CONTRACT CHANGE ORDER NO. 1

AIRPORT: Orcas Island Airport
LOCATION: Eastsound, WA
PROJECT NAME: Runway, Taxiway, and Apron Pavement Rehabilitation (Overlay, Seal Coat and Crack Sealing)
PROJECT NO: AIP 3-53-0024-024-2025, AIG 3.-53-0023-023-2025
CONTRACTOR: Granite Construction Company
DATE: 10/23/2026

17

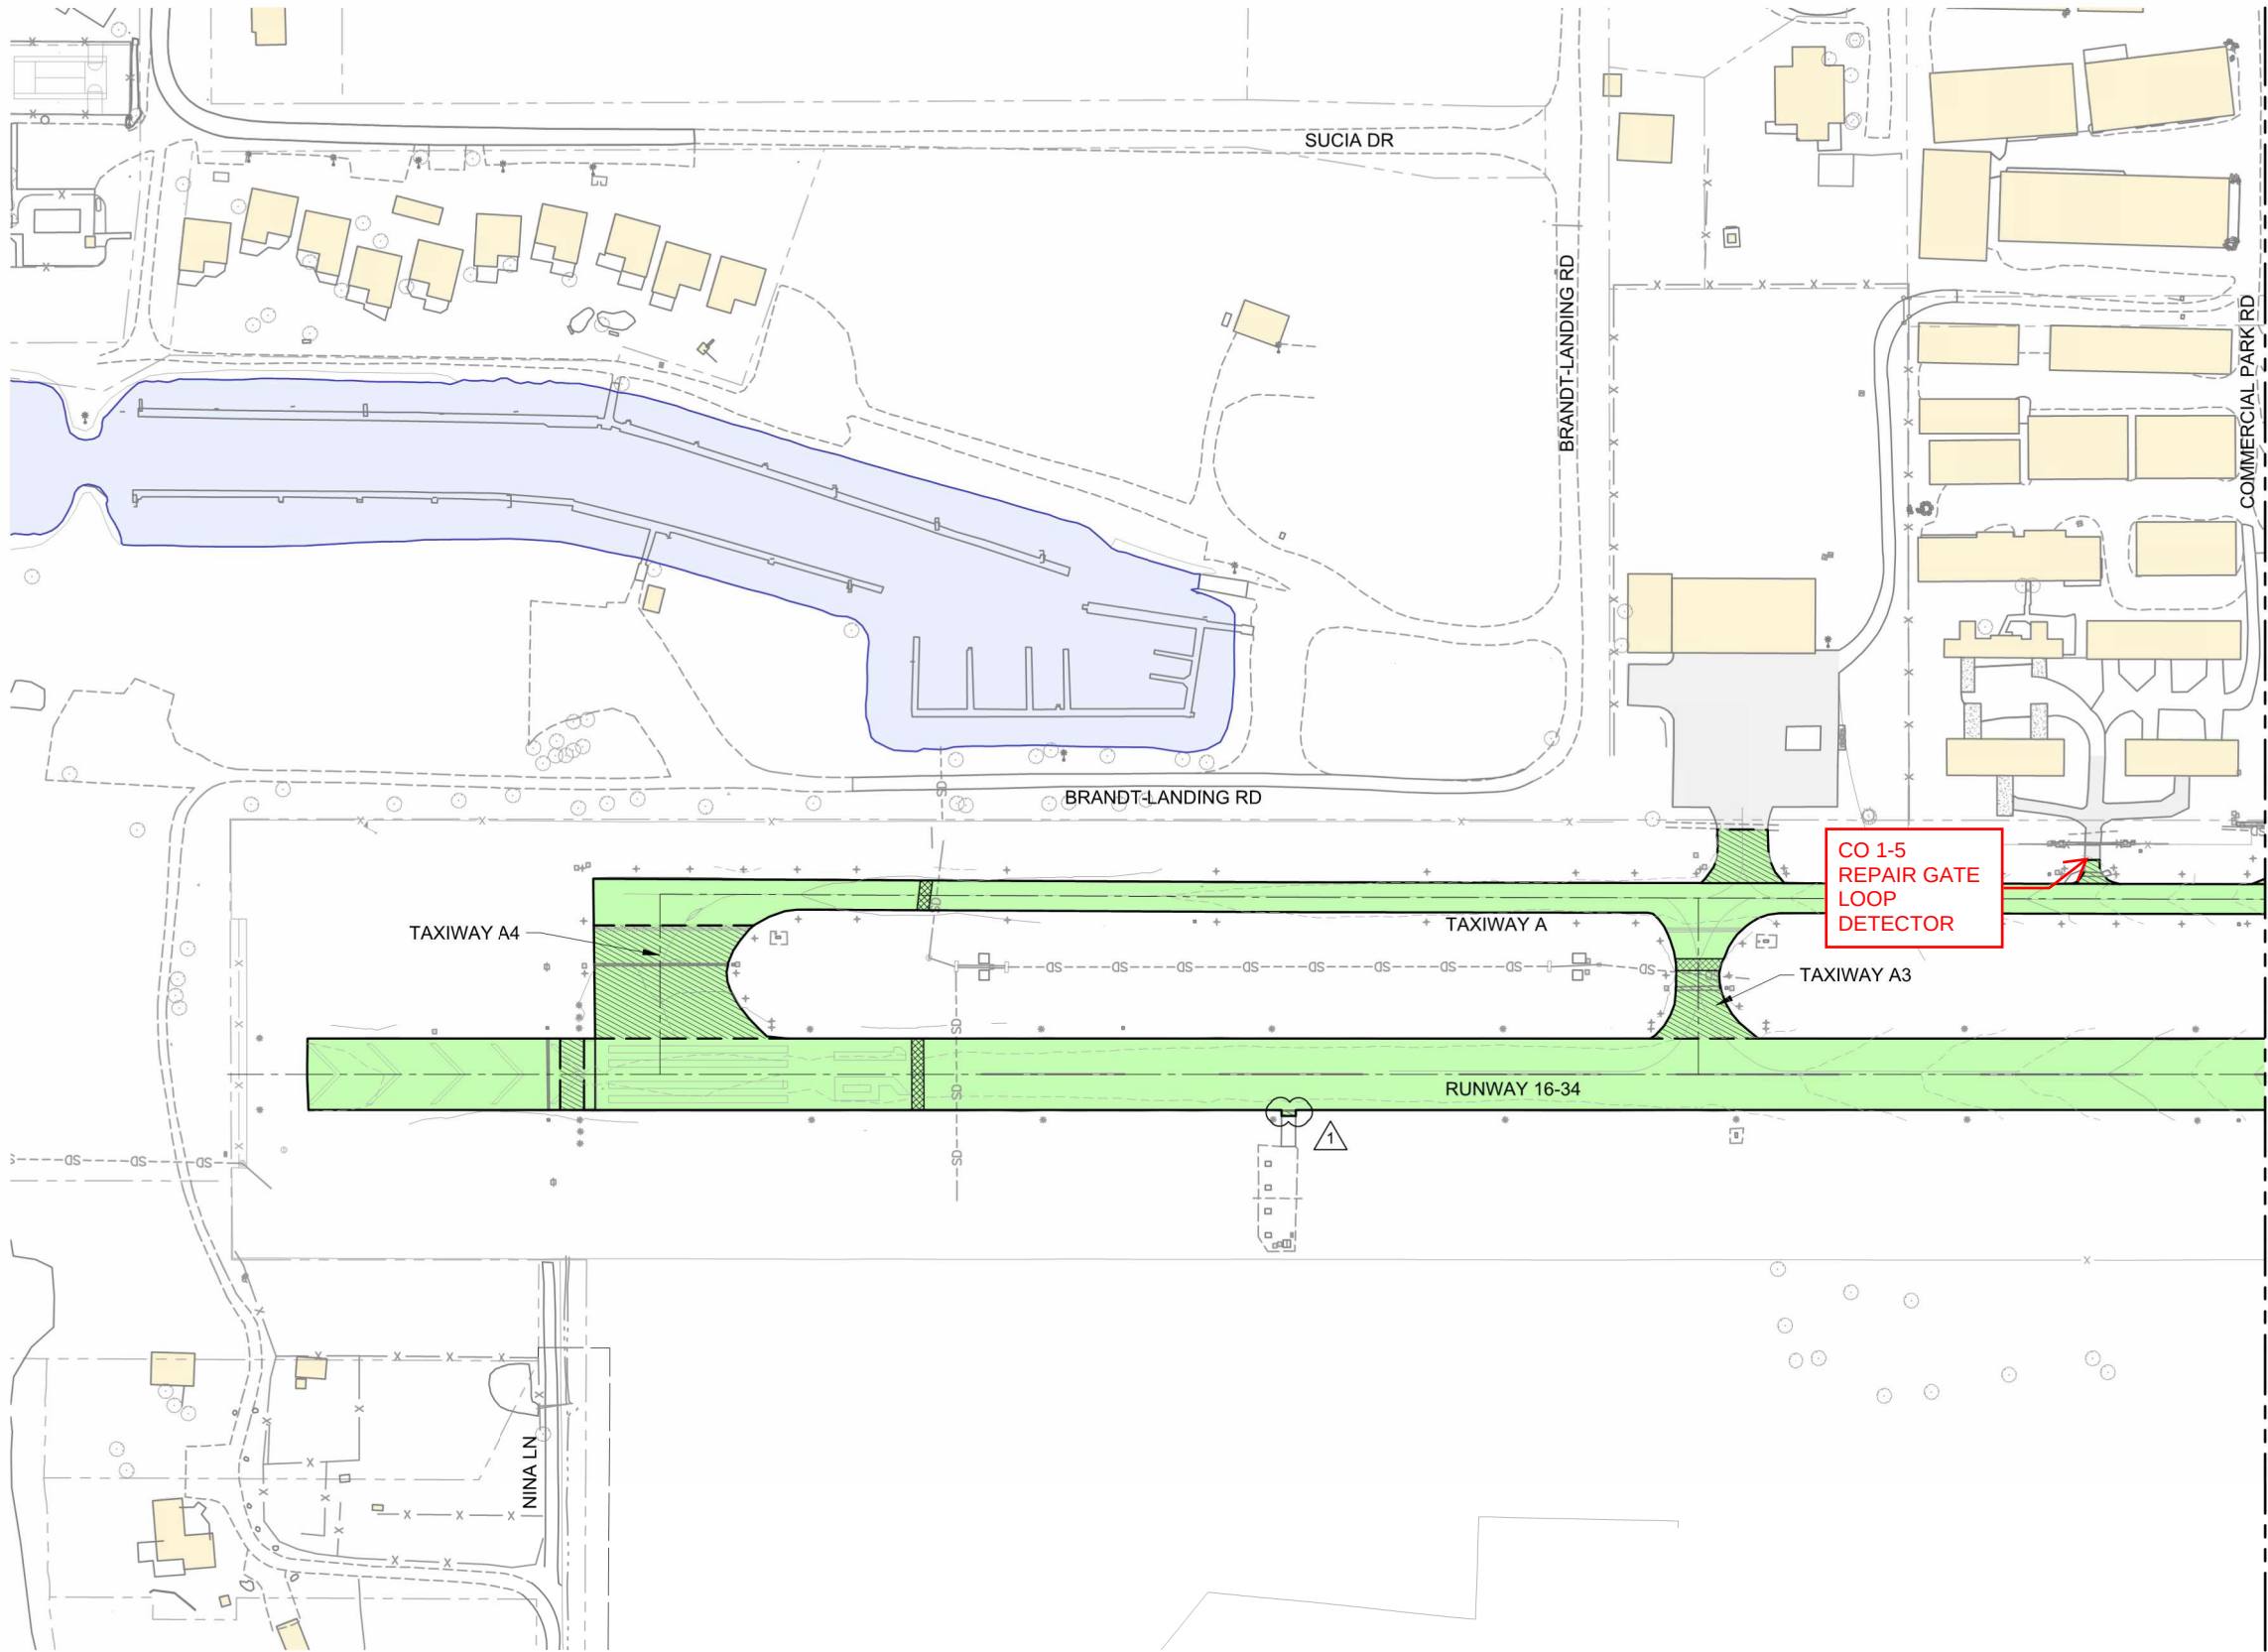
CO 1-1: Core new catch basin and upsize one pipe connection from 18" to 24", see attached drawings.
CO 1-2 Remove and dispose of an abandoned drainage pipe near a new catch basin, see attached drawings.
CO 1-3: Connect an existing 12" drainage pipe to a new catch basin, see attached drawings.
CO 1-4: Demolish an existing concrete foundation under the apron and dispose offsite, see attached drawings.
CO 1-5: Repair the airside gate loop detector in the taxilane east of Taxiway A, see attached drawings.
CO 1-6: Install ORS identifier markings, see attached drawings.

CO 1-1: During construction this existing pipe was found to be 24" instead of the 18" anticipated.

CO 1-2: This previously unknown existing drainage pipe was encountered and had to be removed to allow installation of a new storm structure.

CO 1-3: This previously unidentified 12" drainage pipe was discovered during construction and required an additional connection the new catch basin.

18

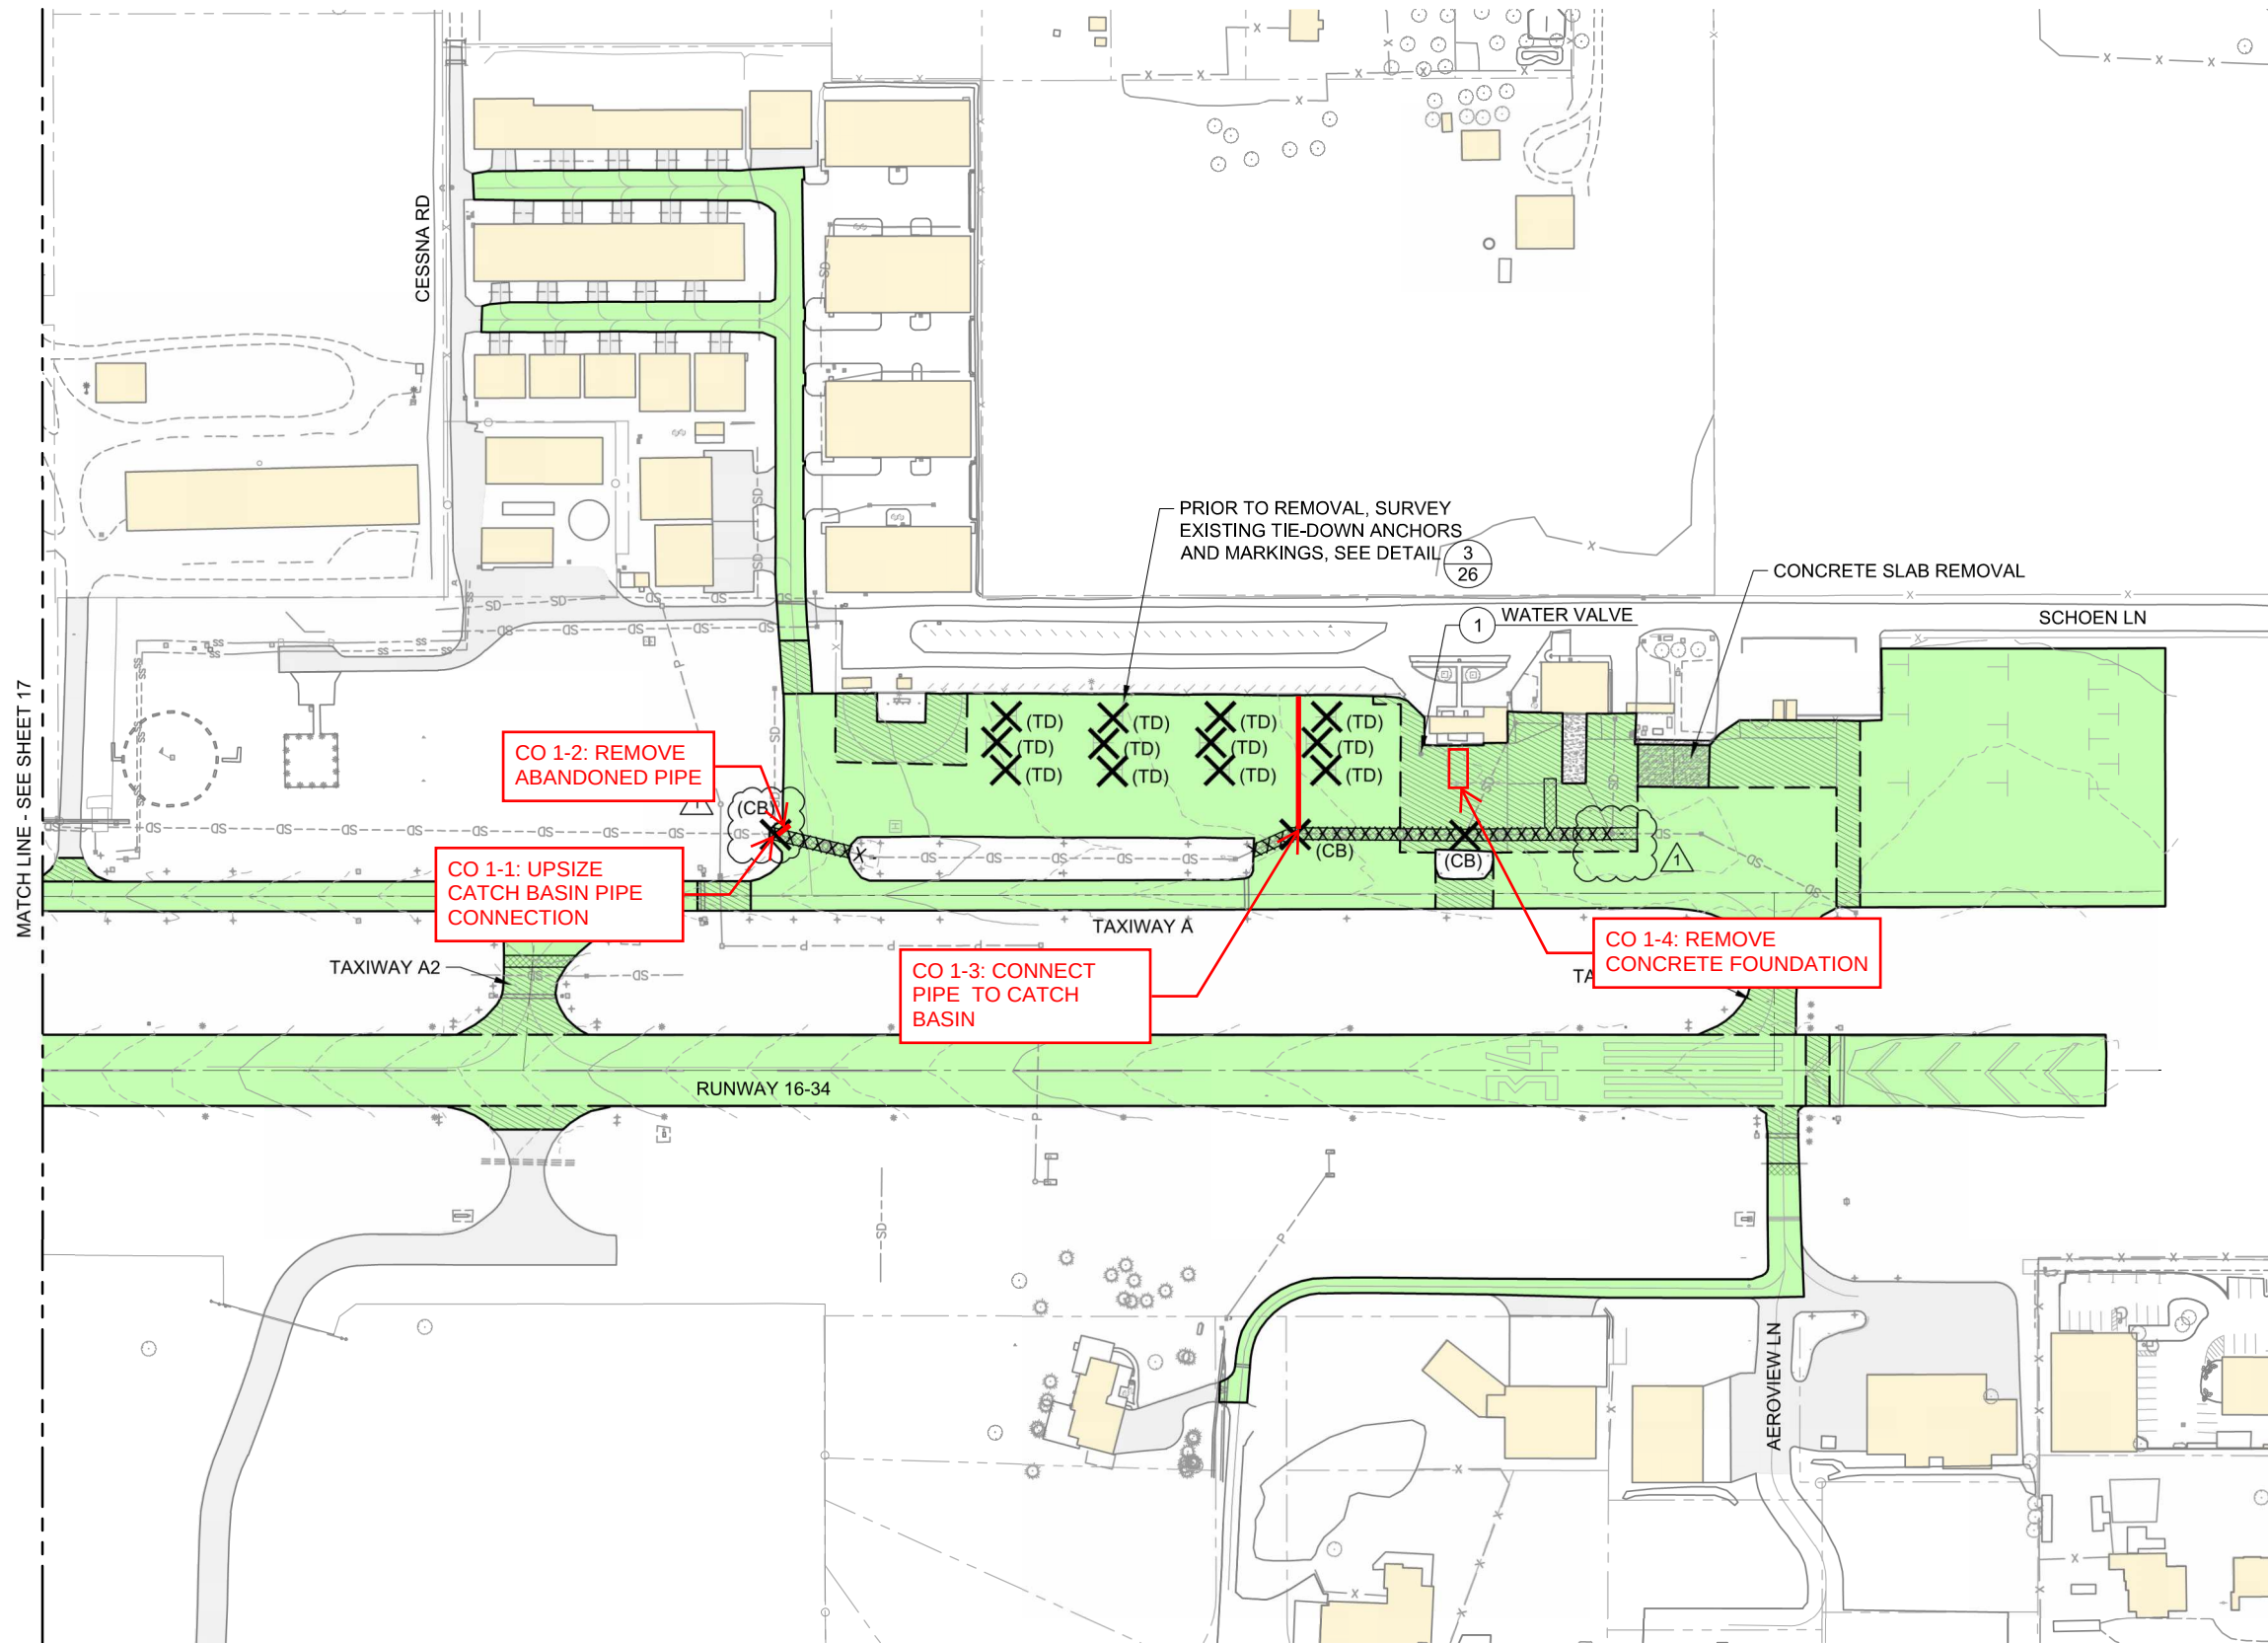
CO 1-4: Removal of this previously unknown concrete foundation was required to allow pavement transition work in this location.

CO 1-5: This loop detector was cut when additional pavement was removed to better transition from Taxiway A to the adjacent taxilane.

SHEET NO.
34
OF **37**

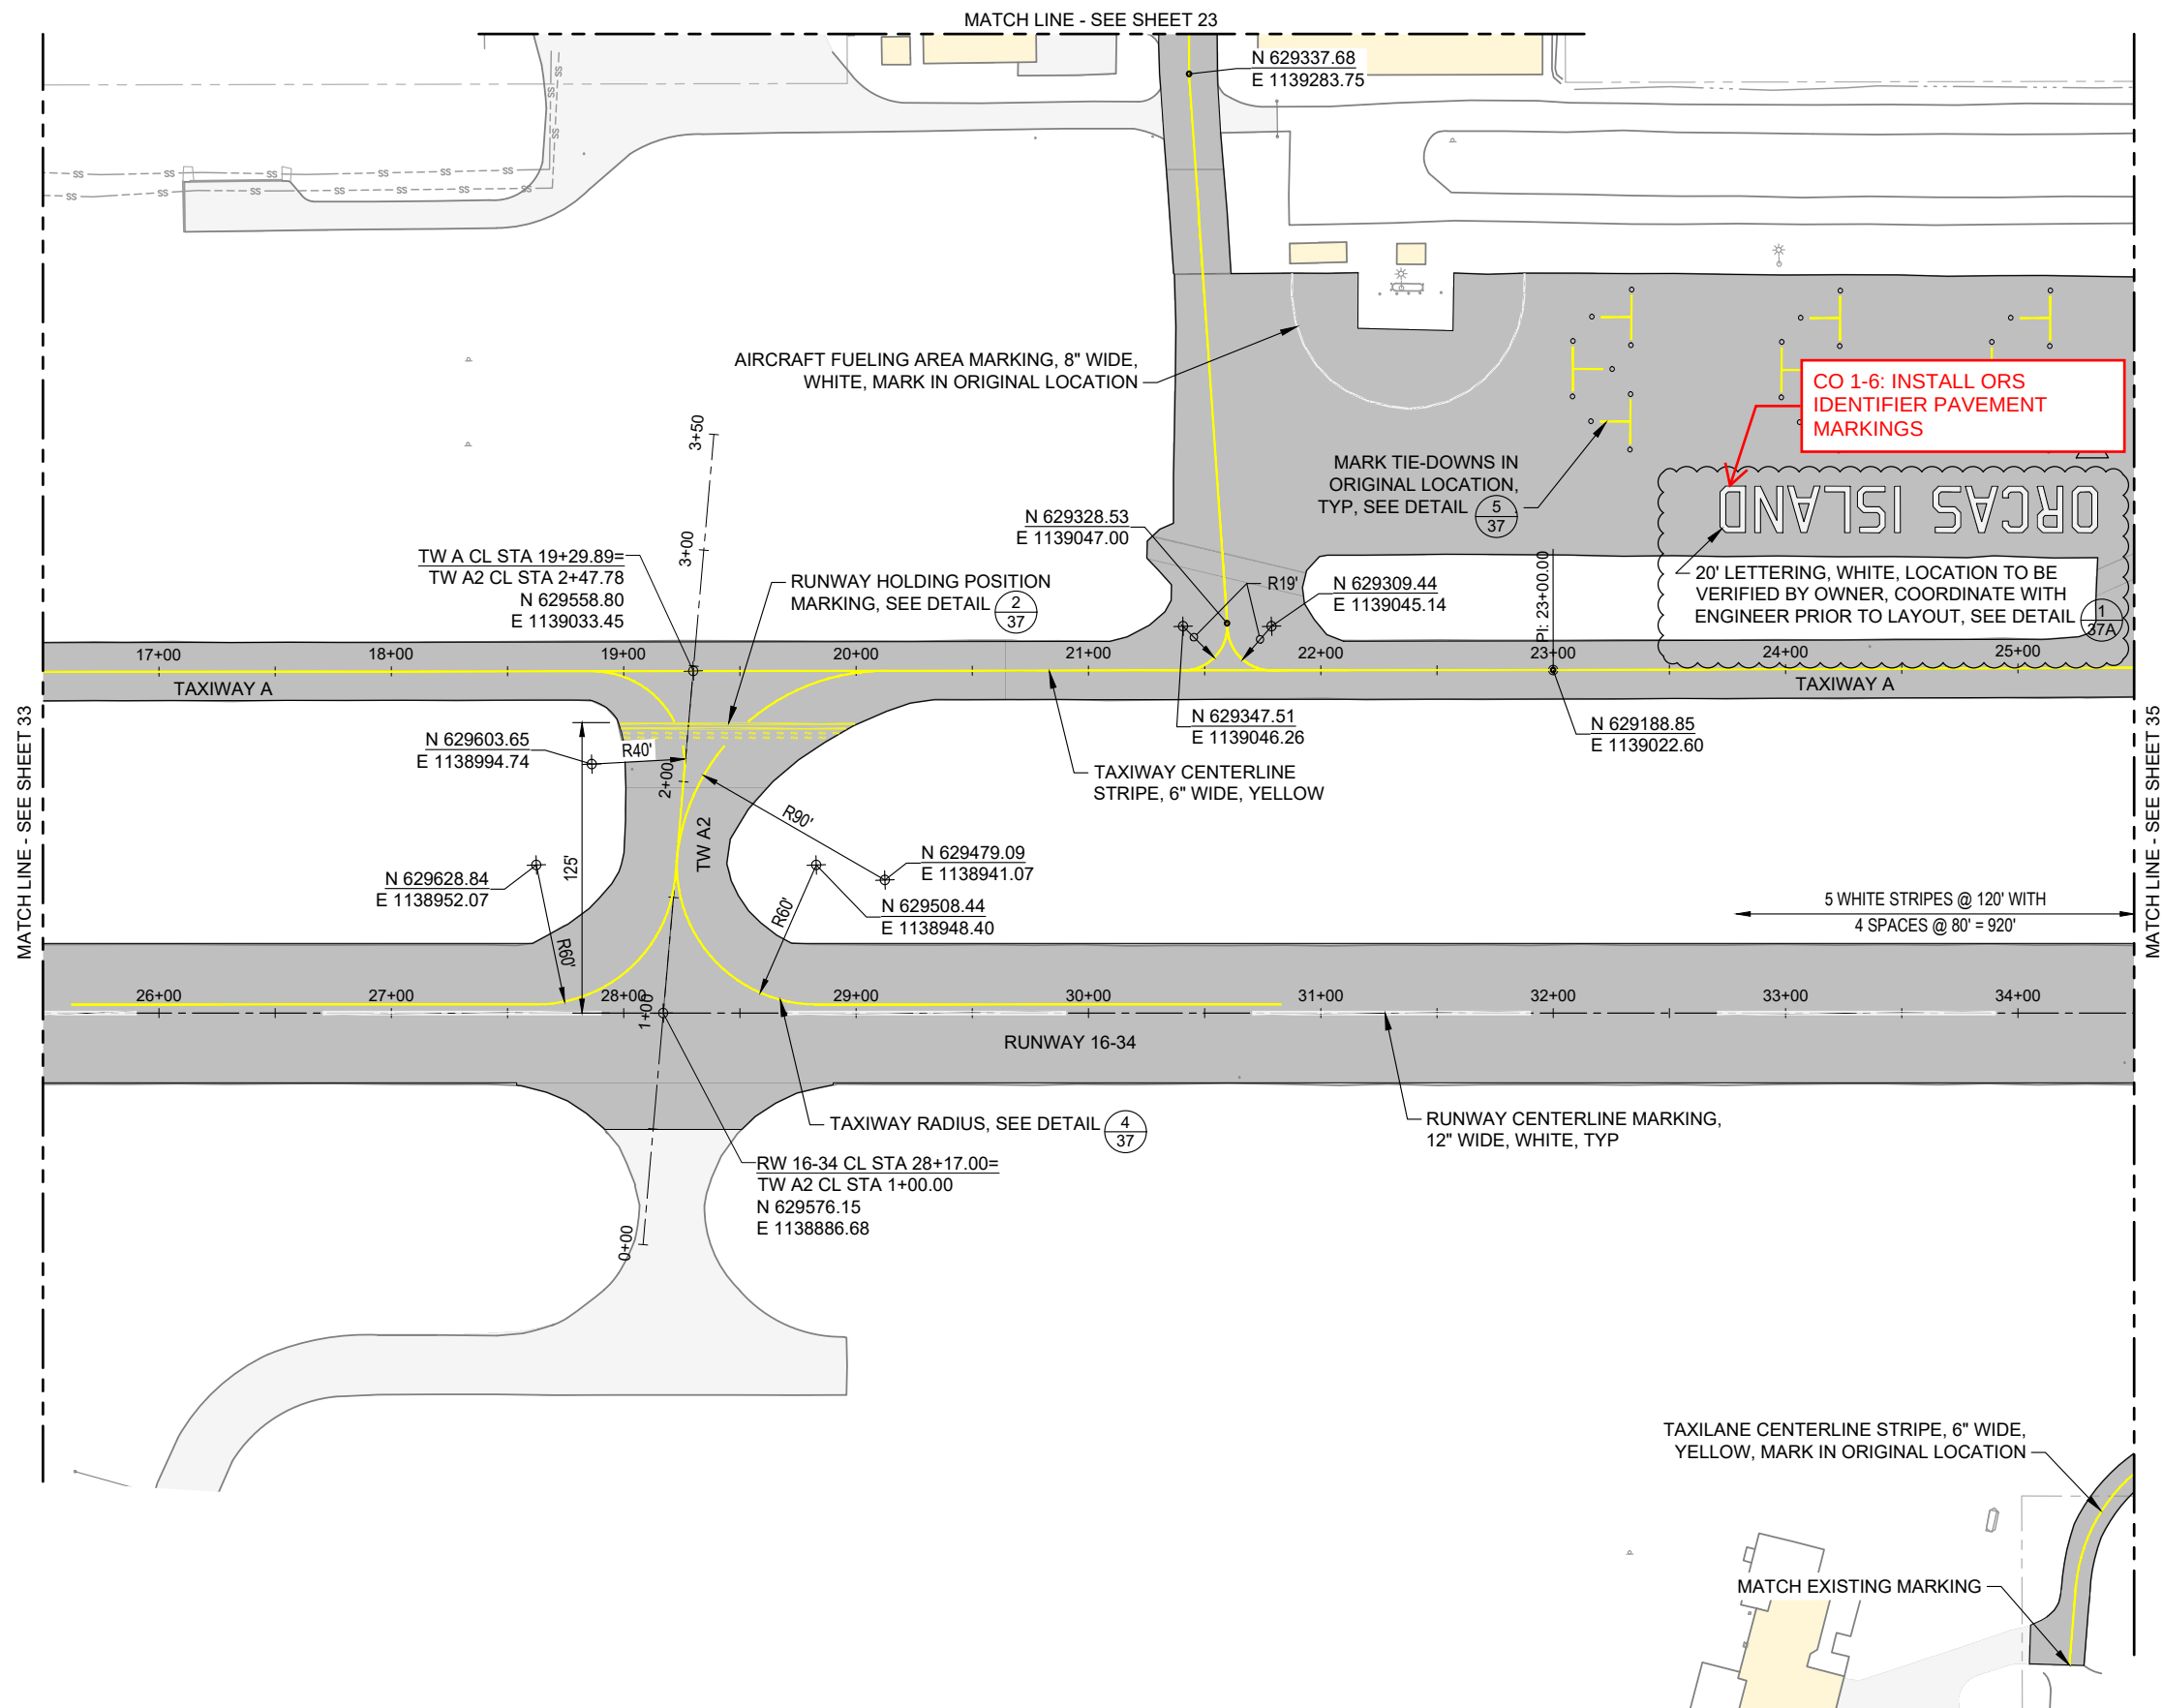
CO 1-6: ORS identifier pavement markings were added to the project after bid opening.
